Planning Commission Staff Report

Project Type: Site Development Plan

Description: **Highland on Conway (Delmar Gardens III) SDP**: A Site Development Plan, Tree Stand Delineation, Tree Preservation Plan, Landscape Plan, Lighting Plan, and Architectural Elevations for a 5.292 acre tract of land zoned “PC” Planned Commercial District located on the north side of North Outer 40 Road, east of Chesterfield Parkway East.

Project Narrative

SITE SECTION A-A

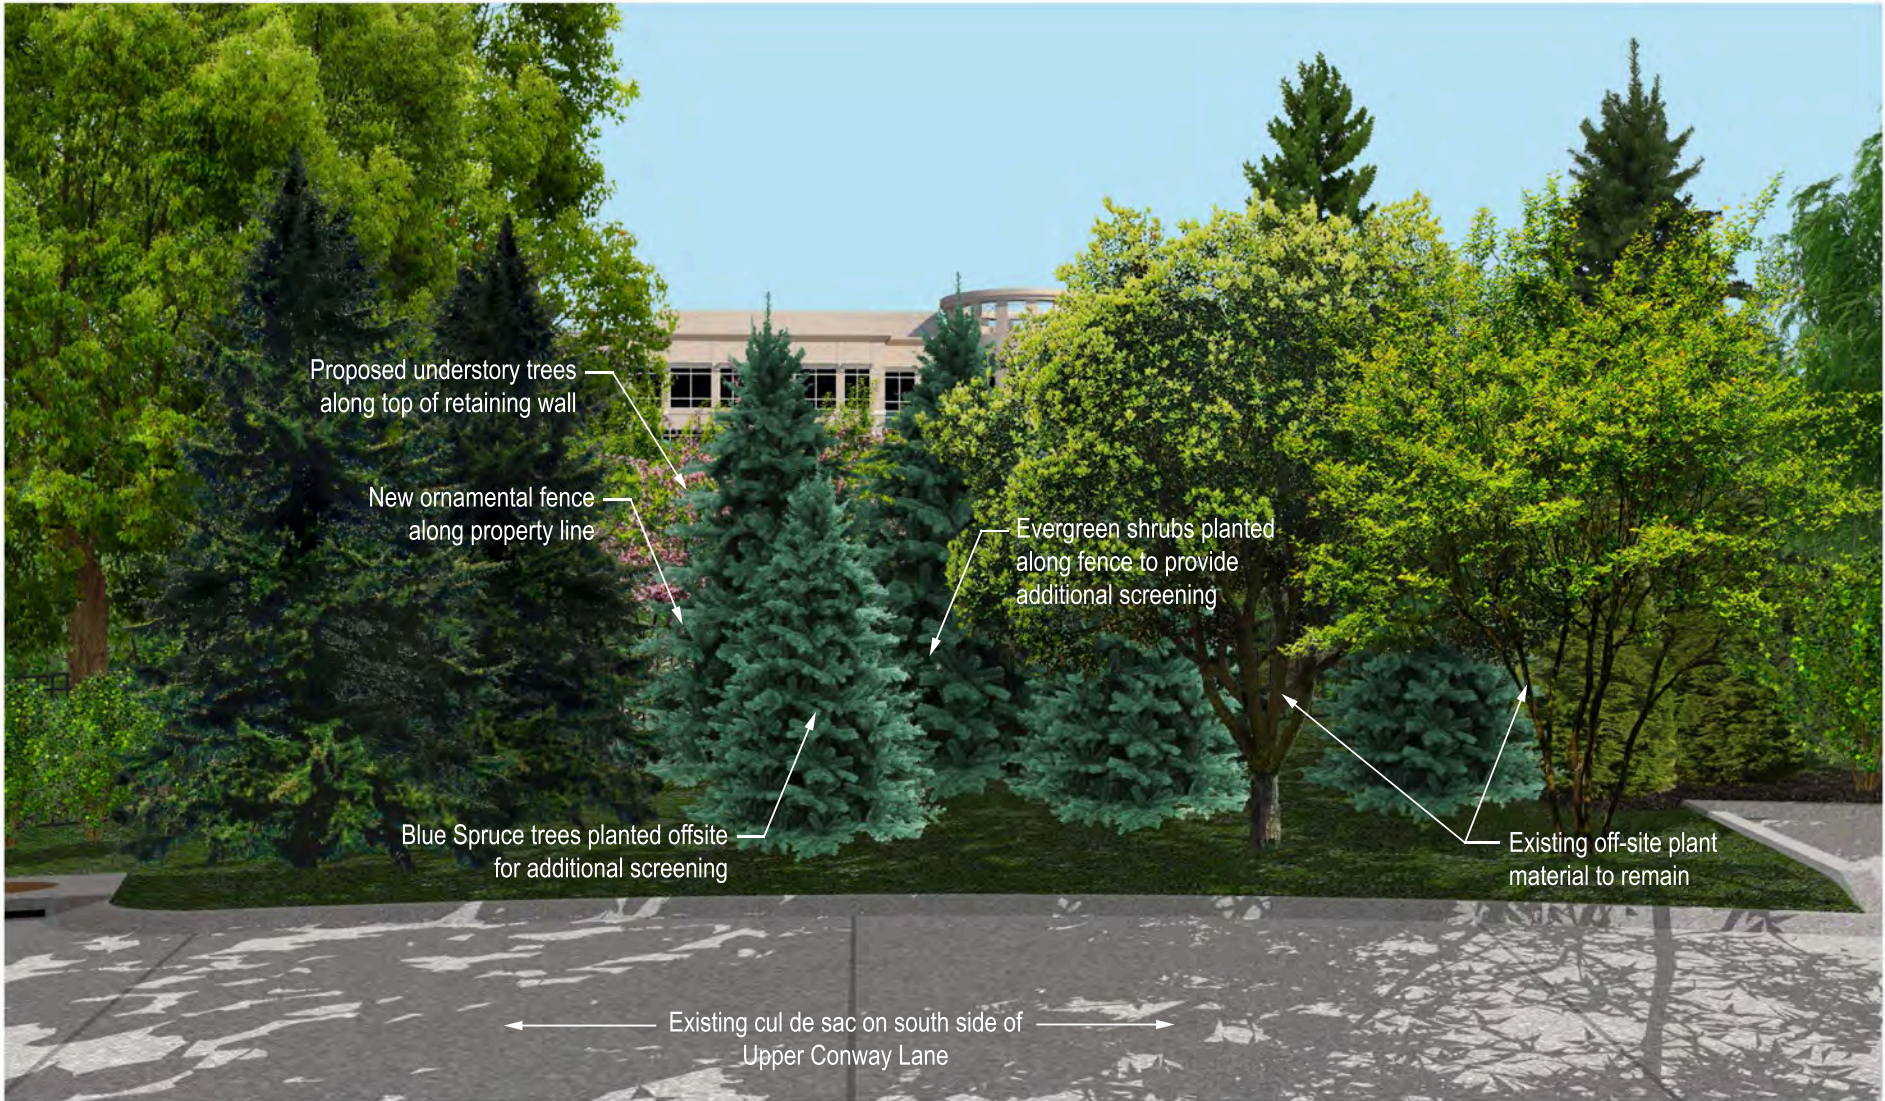
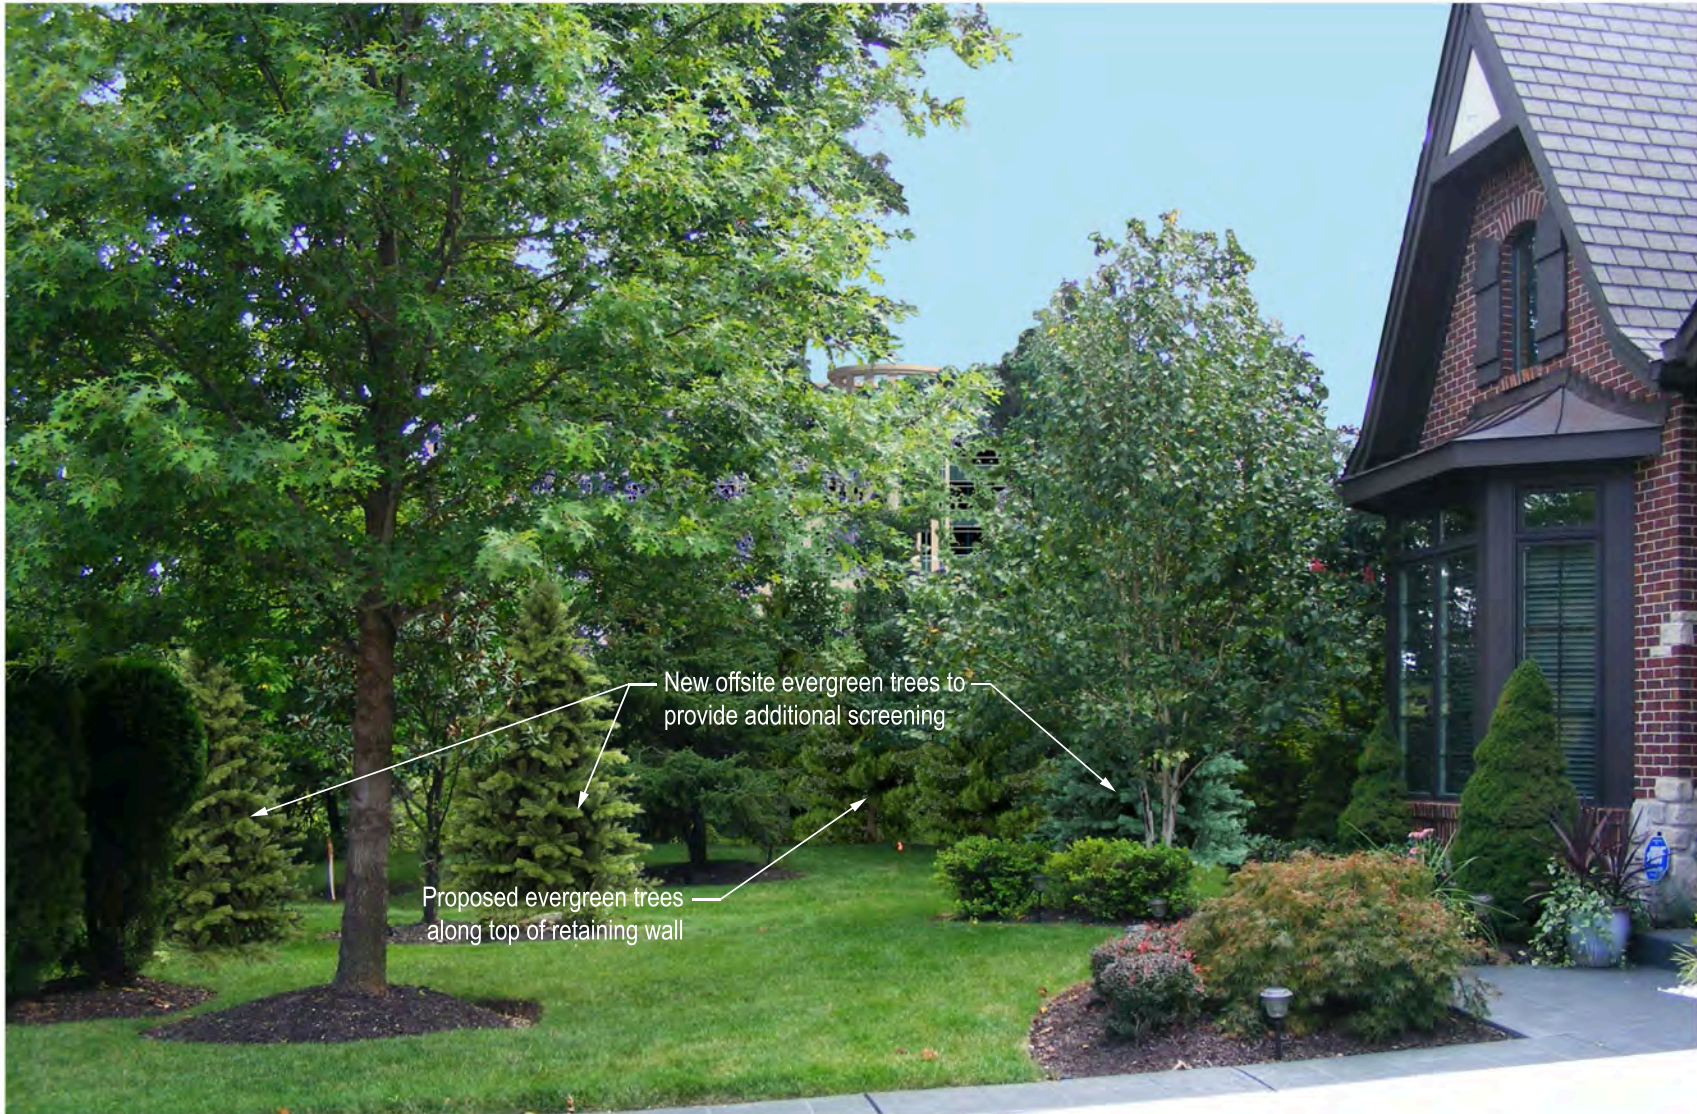
There were various questions regarding the proposed retaining wall and heights of the proposed buildings at the August 24, 2015 Planning Commission meeting. These have been addressed in

Due to the existing grades, the garage parapet wall would need to be increased from 3.5' to a height of 14.5' in the western corner and would taper down to the current height of 3.5' as it moves to the east. This would create a significantly different and non-desired architectural appearance of the parking structure. The current proposal allows the developer to include landscaping between the garage and the retaining wall to help soften the view from the parking garage which would not be possible if the garage wall was also the retaining wall.

We have updated our site section to reflect the revised retaining wall design at the proposed parking structure.

A suggestion was made during these neighborhood meetings that we extend the height of the parking structure parapet wall to function as a retaining wall in lieu of the proposed site retaining walls. We studied this possibility and determined that it is not a viable solution. Extending the height of the parapet wall would create a tall "architectural" element that we would not be able to soften with landscape. It will appear awkward and ungainly from the parking structure and the office building. Modular site walls are used throughout the Delmar Gardens 1 & II property to make such transitions of grade. With landscape elements above and below these walls, they are better suited to this condition both functionally and aesthetically. Our proposed modular retaining wall is setback from the garage wall by 10' allowing dense plantings between the modular wall and the face of the parking structure.

New offsite evergreen trees to provide additional screening

Proposed evergreen trees along top of retaining wall

GARAGE - SOUTH ELEVATION

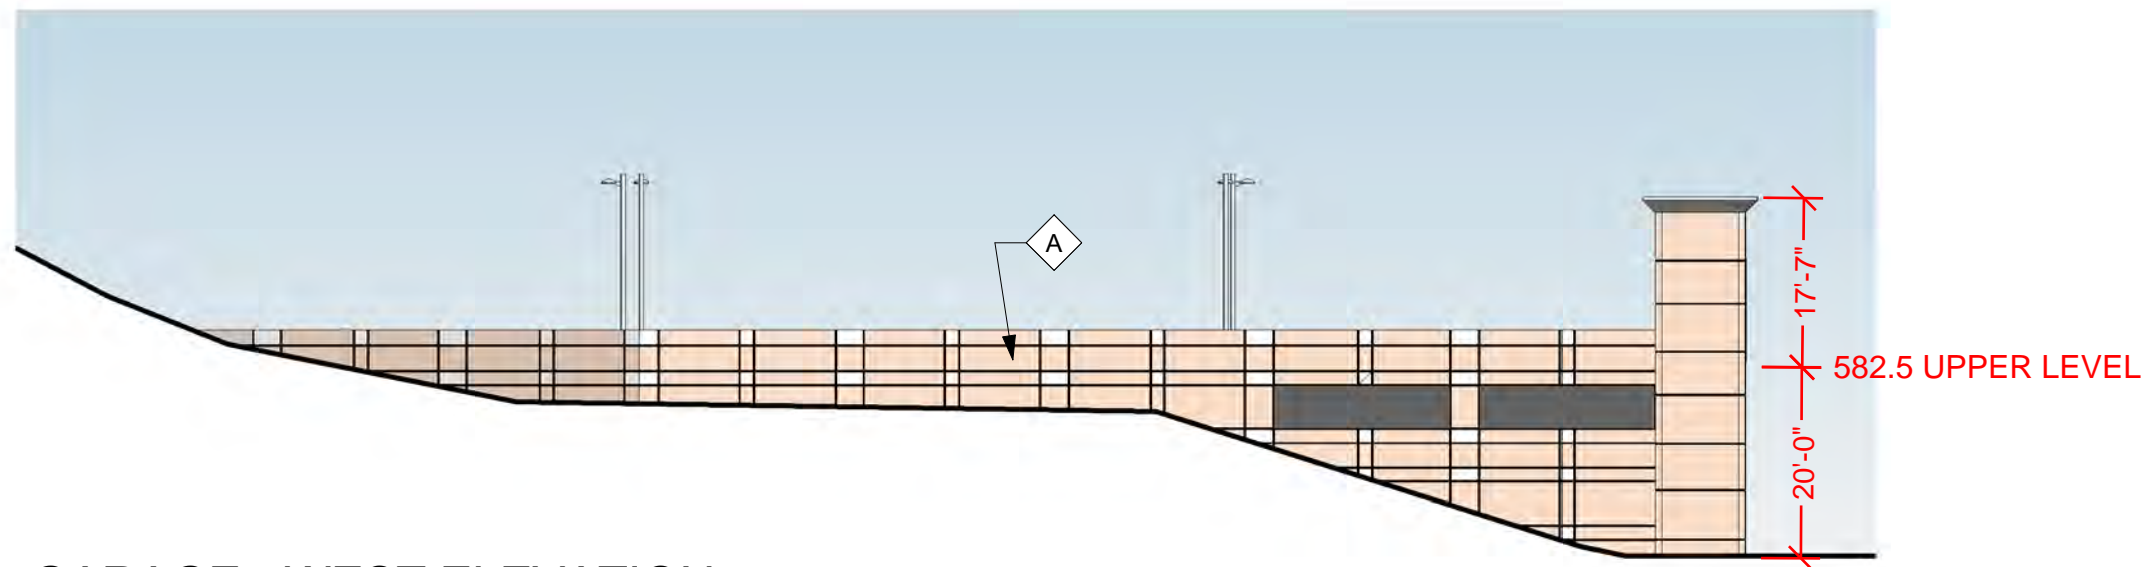
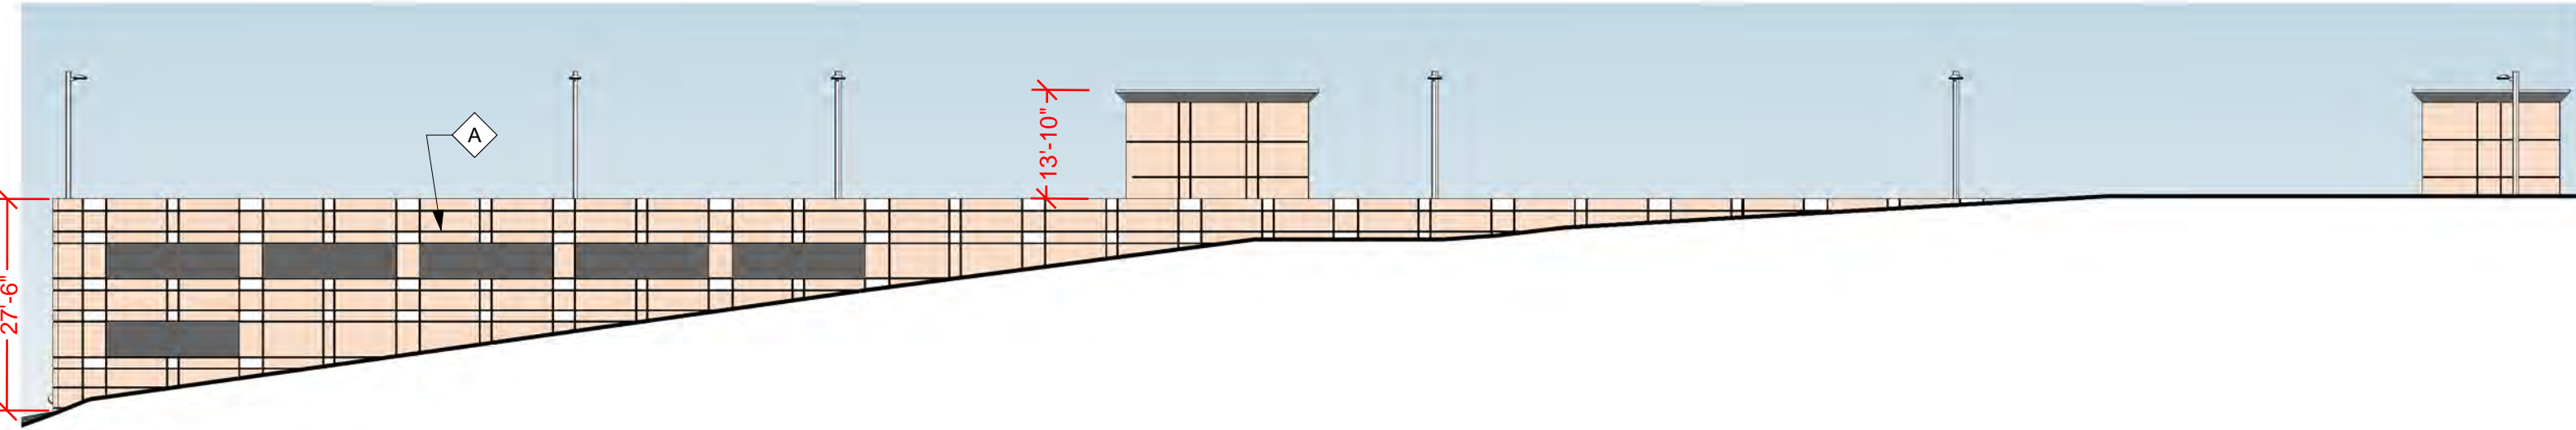
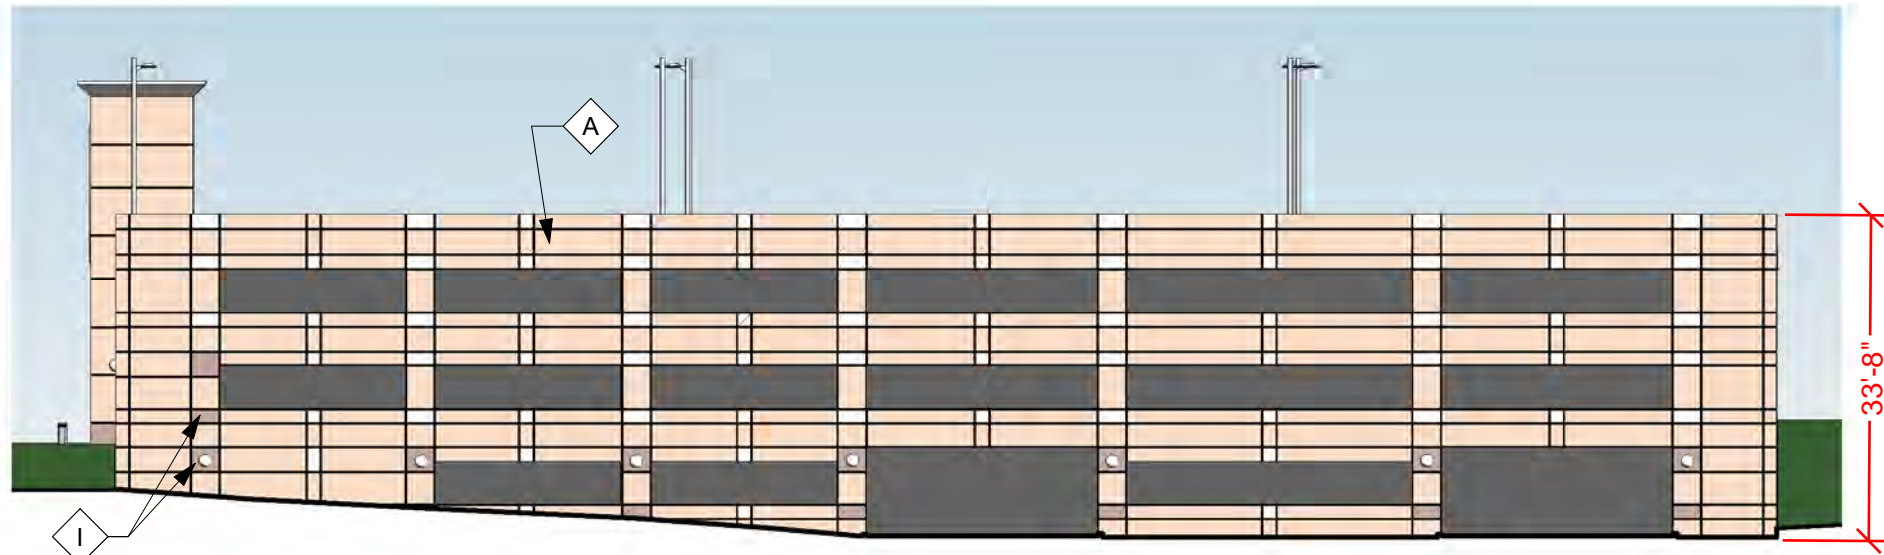
3) Parking structure stairwell enclosure height

Although the stairwells extend 14' above the parapet wall or 17' above the top parking level, they will only be 3.5' above the maximum height of the proposed retaining wall. The stairwells are also located on the south side of the parking structure approximately 200' from the northern property line. This horizontal separation will contribute to the lower visibility of these elements. Additionally, the applicant clarified that the proposed towers were designed to imitate the same size, scale, and proportions of the existing stair enclosures on the adjacent Delmar Gardens property.

Our proposed stairwell towers are the same height as the stairway enclosure constructed on the award-winning DGE I and II campus. Our intention for this new project is to construct a 'sister' building and parking structure to the existing Delmar Gardens campus. We are simply repeating the same size, scale and proportions of the current stair tower.

About 13' of the stair enclosure accommodates circulation, decorative lighting and overhead structure to enclose the staircase volume. Another 4' of the enclosure is the aesthetic cornice element consistent with the design of the adjacent office building to the south. (The ordinance sets the maximum height of the top parking level at 585. We are therefore 2.5' below the height limitation for the parking structure.)

The stair towers are located on the south side of the parking structure over 200' from the north property line. While our stair towers are somewhat taller than the functional 'requirement', they are part of the overall architectural composition which was unanimously approved by the City of Chesterfield Architectural Review Board on 09 July 2015. Many times, good design practices require going beyond the function and to consider the aesthetics of the element within the context of the overall design.
